RE: ADDITIONAL TREE INFORMATION - YEOMAN HALL

PROJECT YEOMAN HALL, SLEIGHTS.

TITLE EXISTING & PROPOSED SITE LAYOUTS AND SITE LOCATION

DRAWING NO. YH PL-01

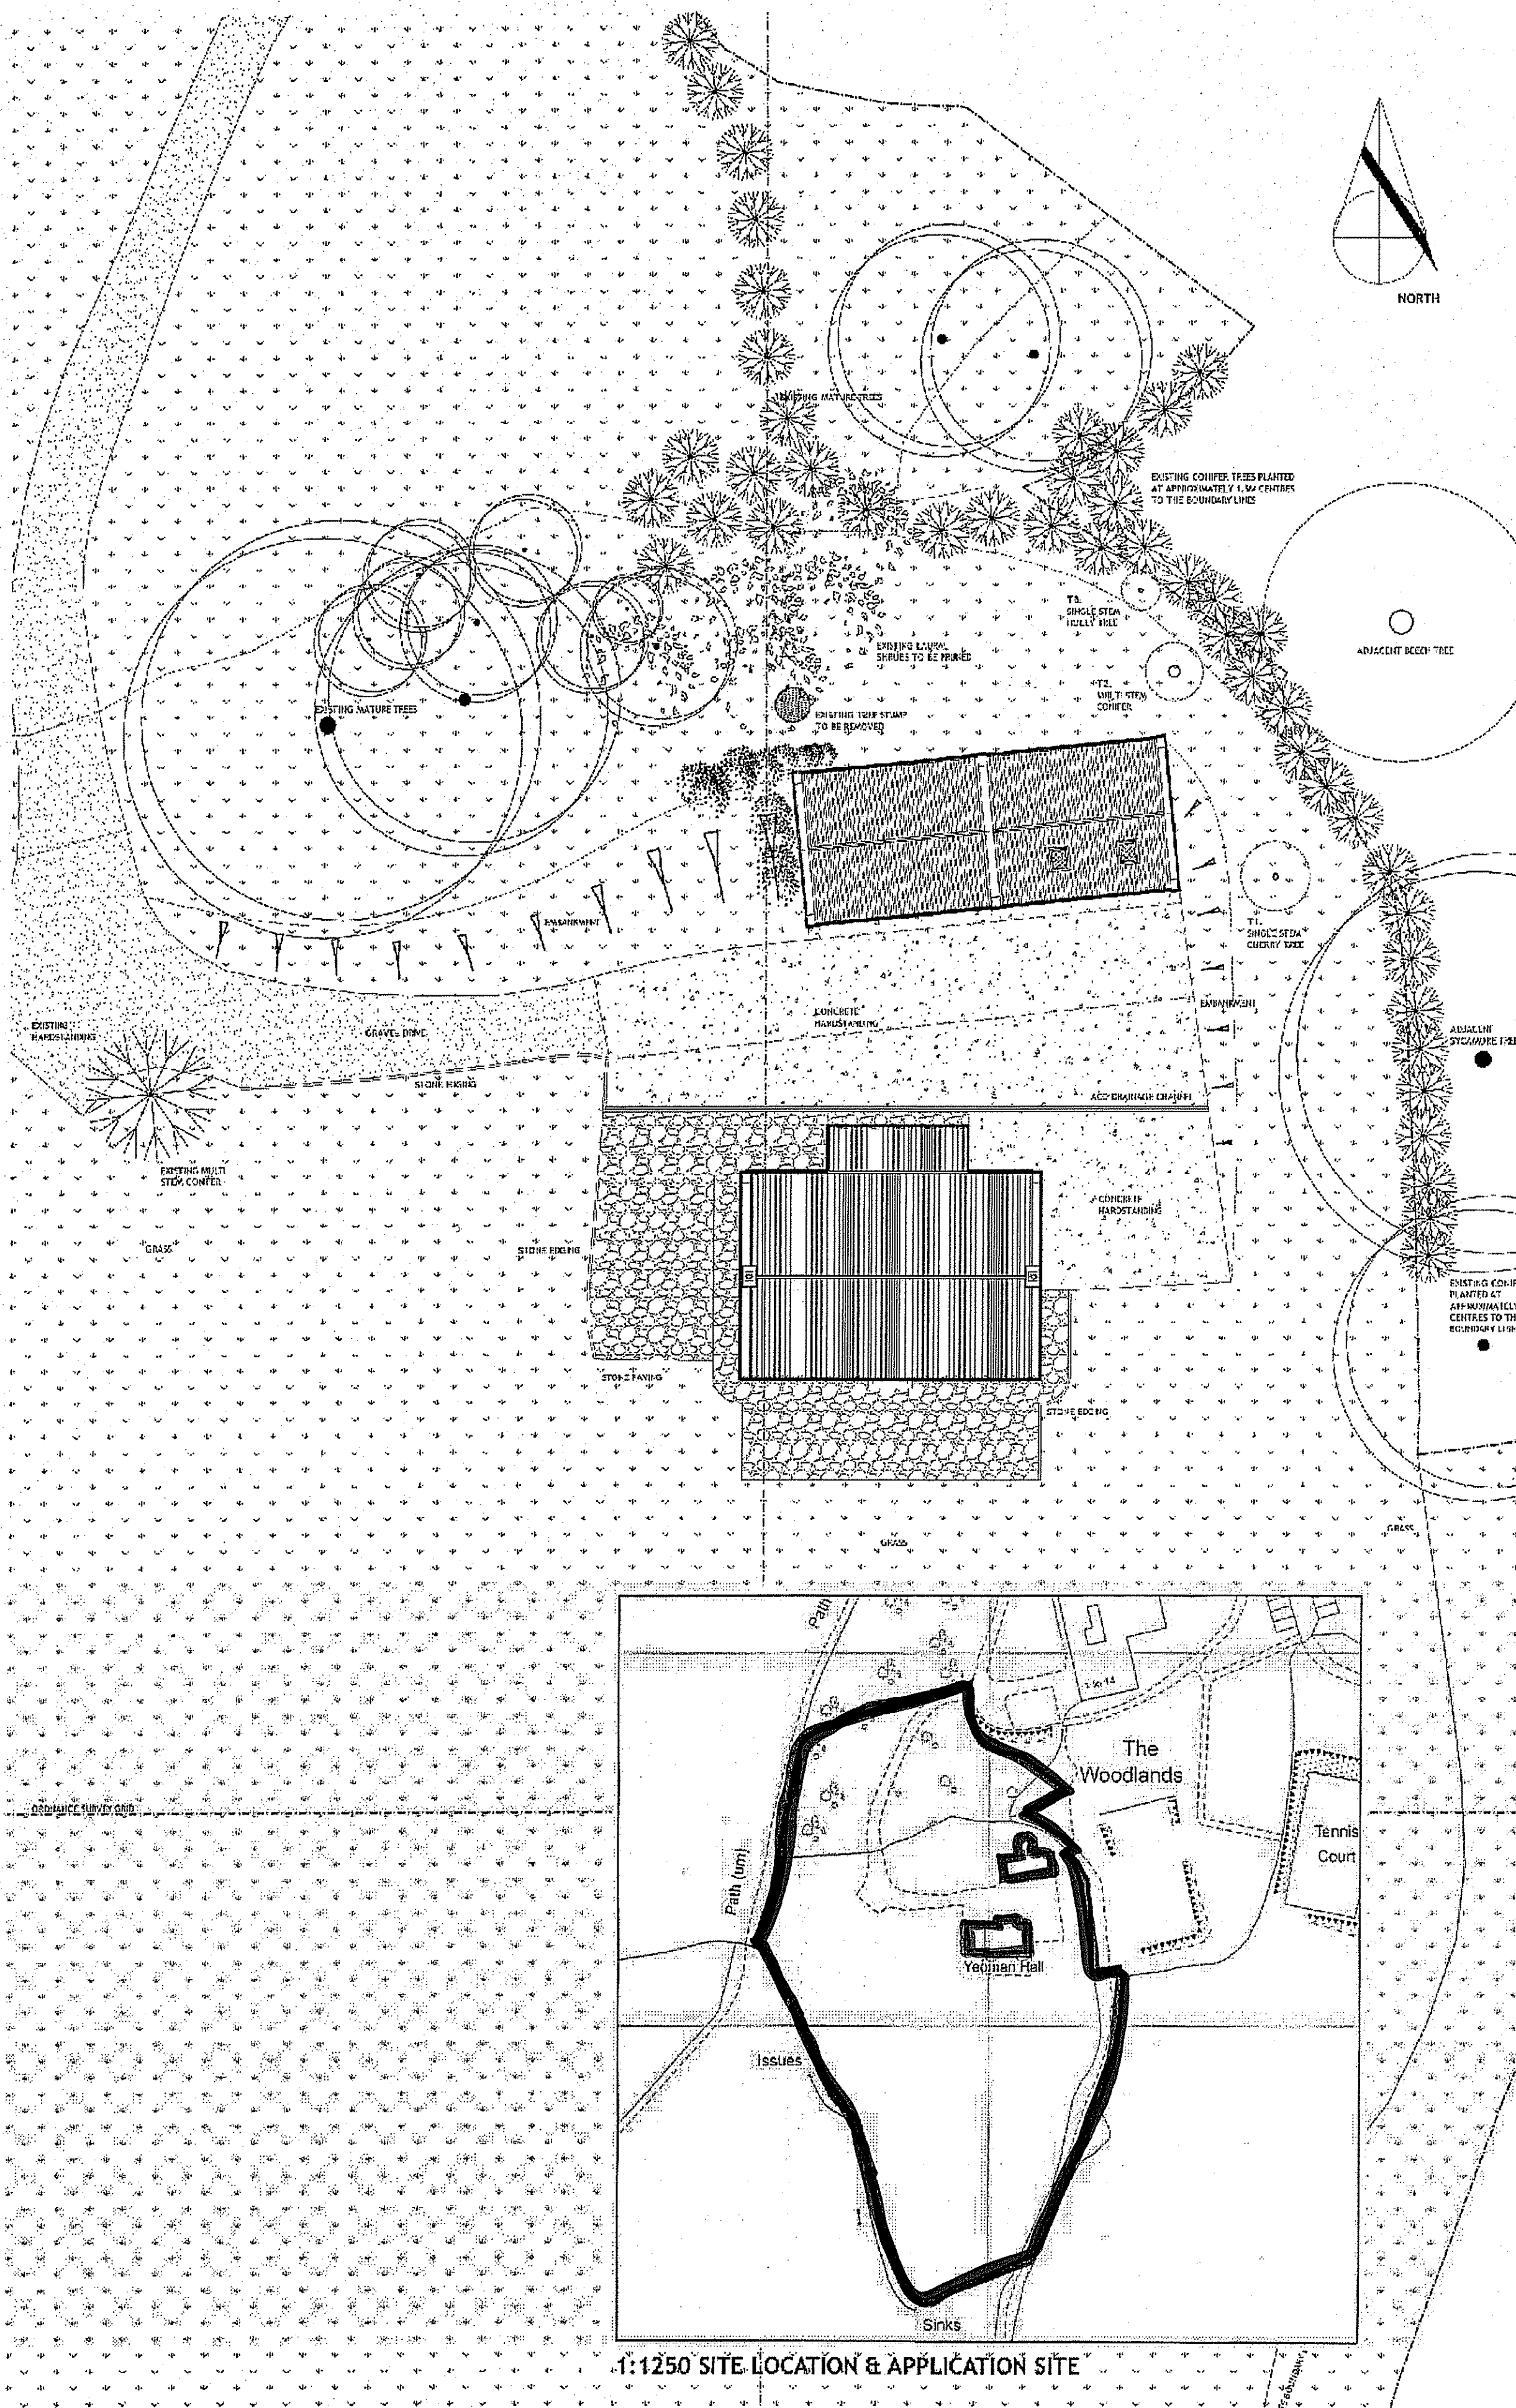
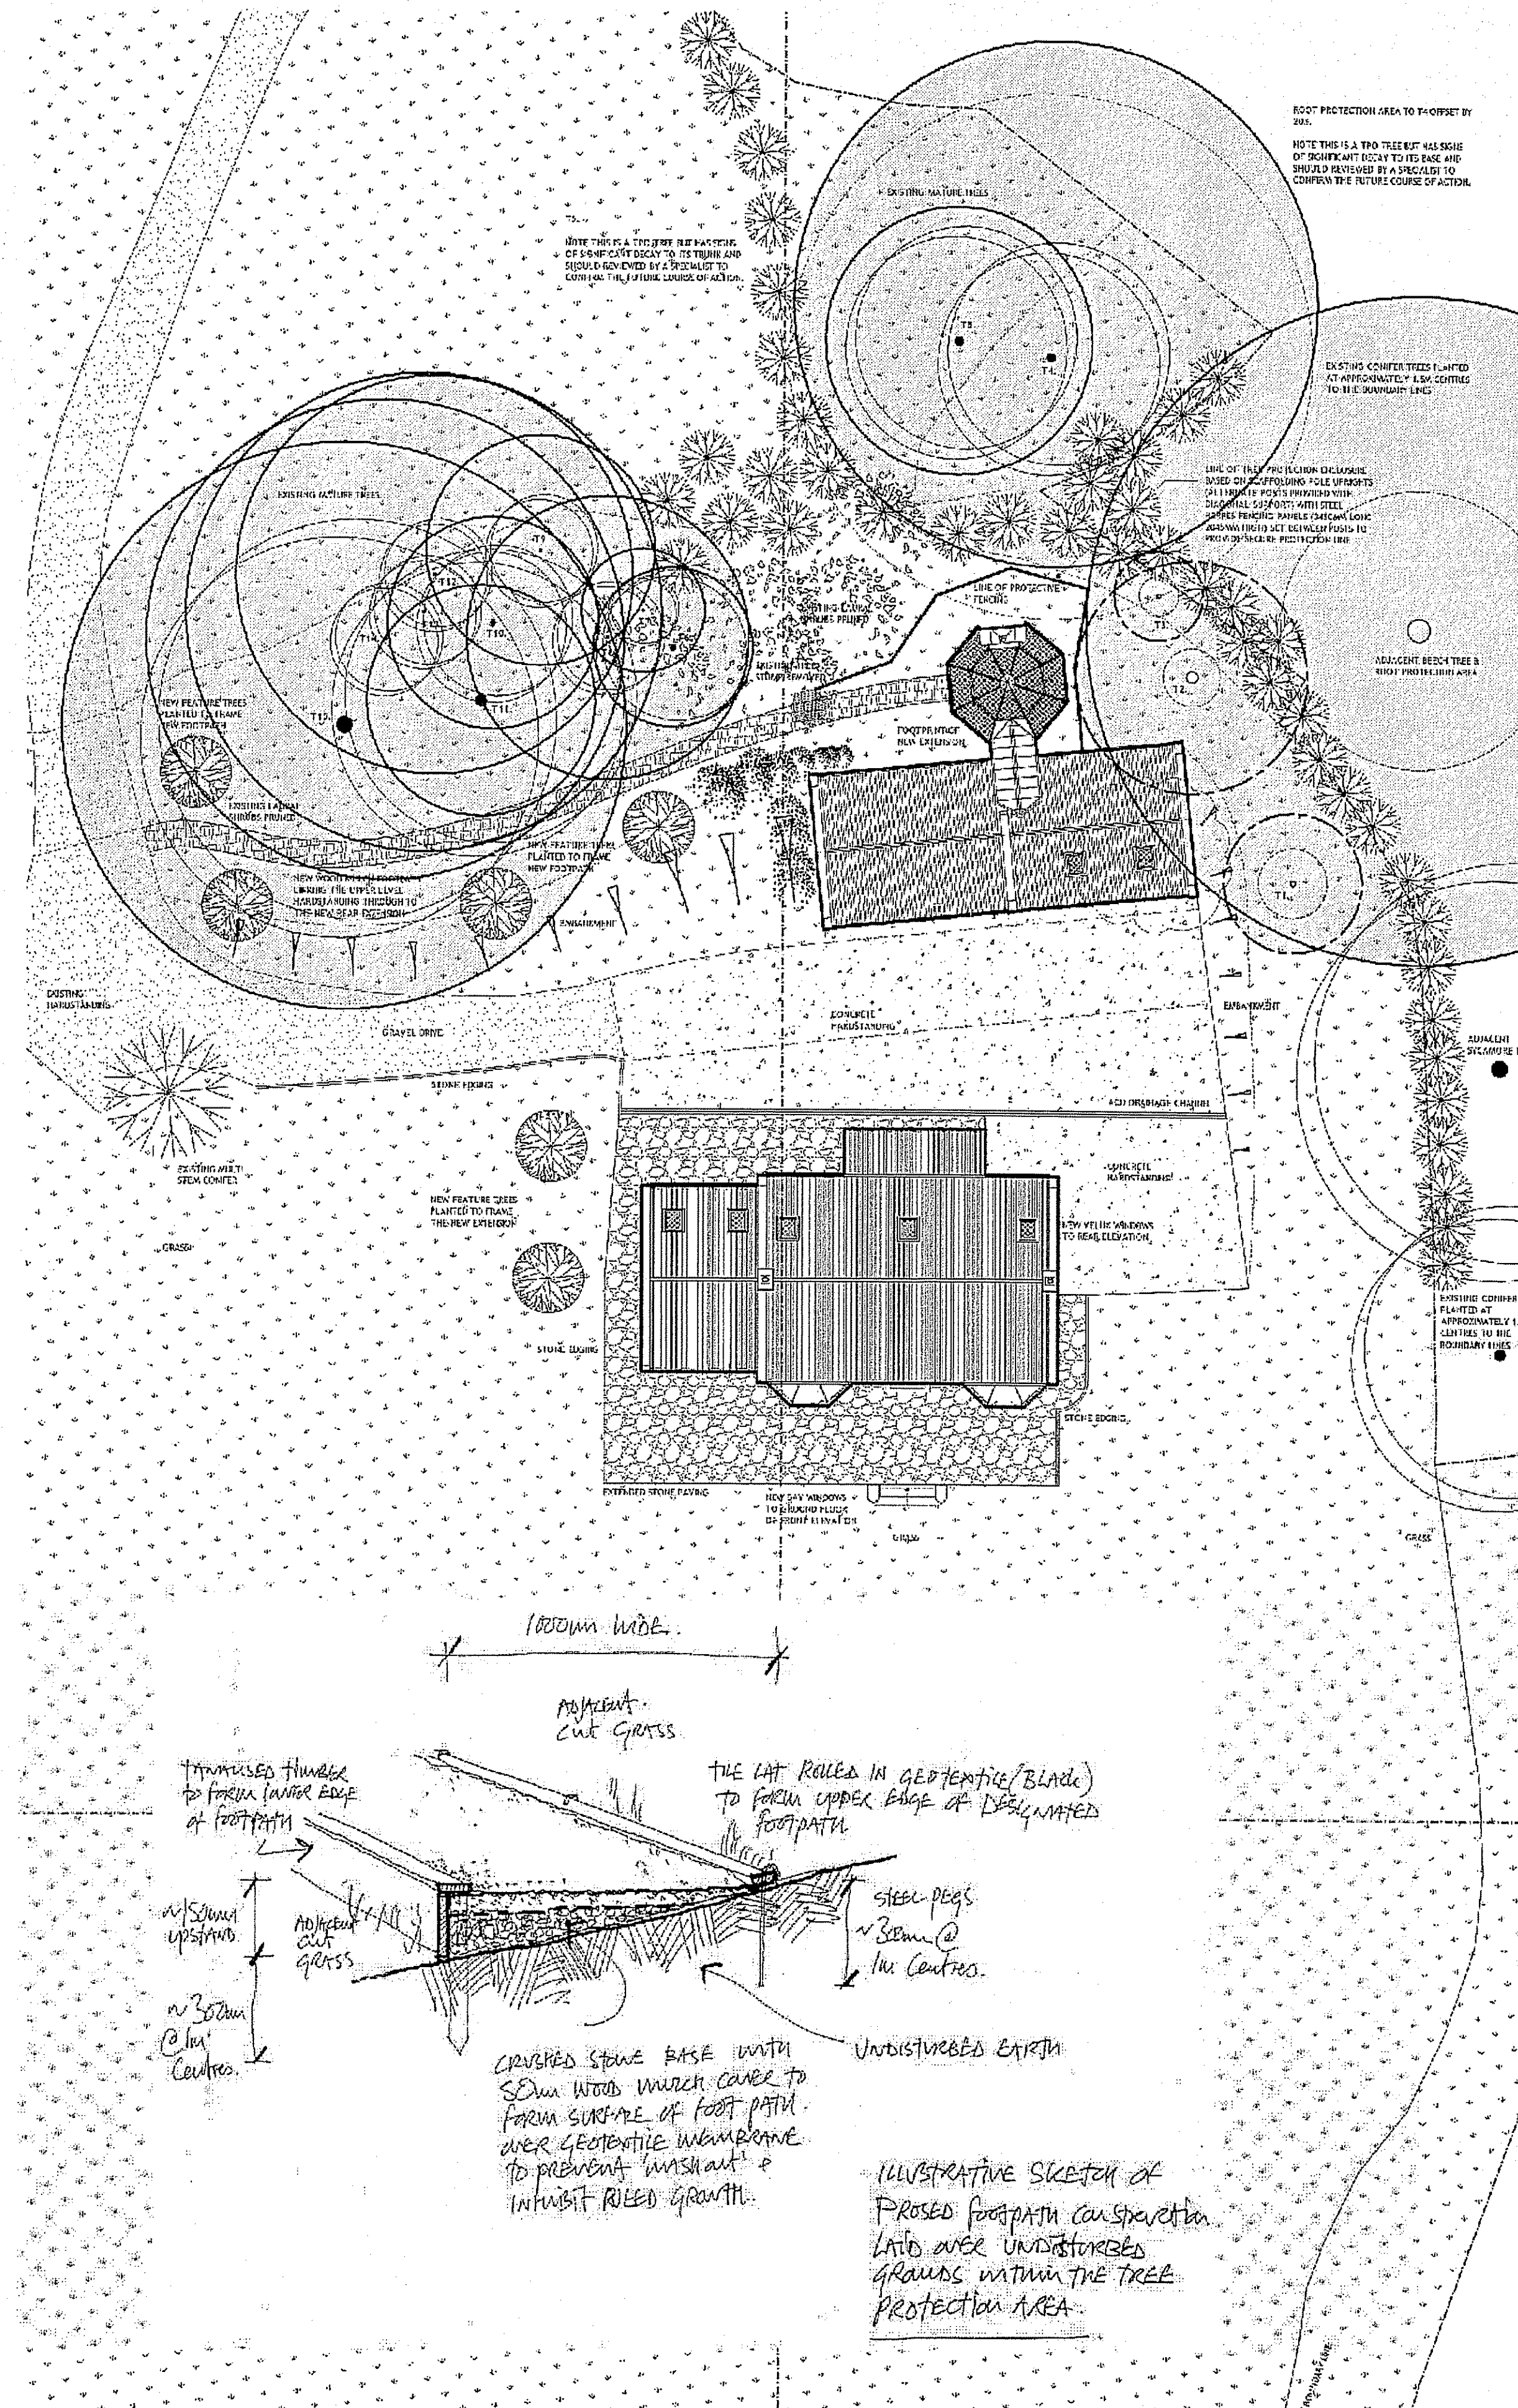
REVISION C - 14 JULY 2010 - JD
Site meeting held with Paul Harris, North York Moors Woodlands Officer. Detailed review of all mature trees adjacent to the proposed works along with confirmed writing out, root protection areas calculated and agreed protective function. Drawing updated to include all the agreed information resulting from the site meeting held.

INDIVIDUAL ROOT PROTECTION AREAS SHOWN HAVE BEEN CALCULATED ON THE BASIS OF TABLE 2 OF BS 5837:2005.

ROOT PROTECTION AREAS FOR THE TREES LISTED ABOVE IS HIGHLIGHTED IN BLUE TO ILLUSTRATE THE PROXIMITY OF THE RPA IN RELATION TO THE NEW REAR EXTENSION.
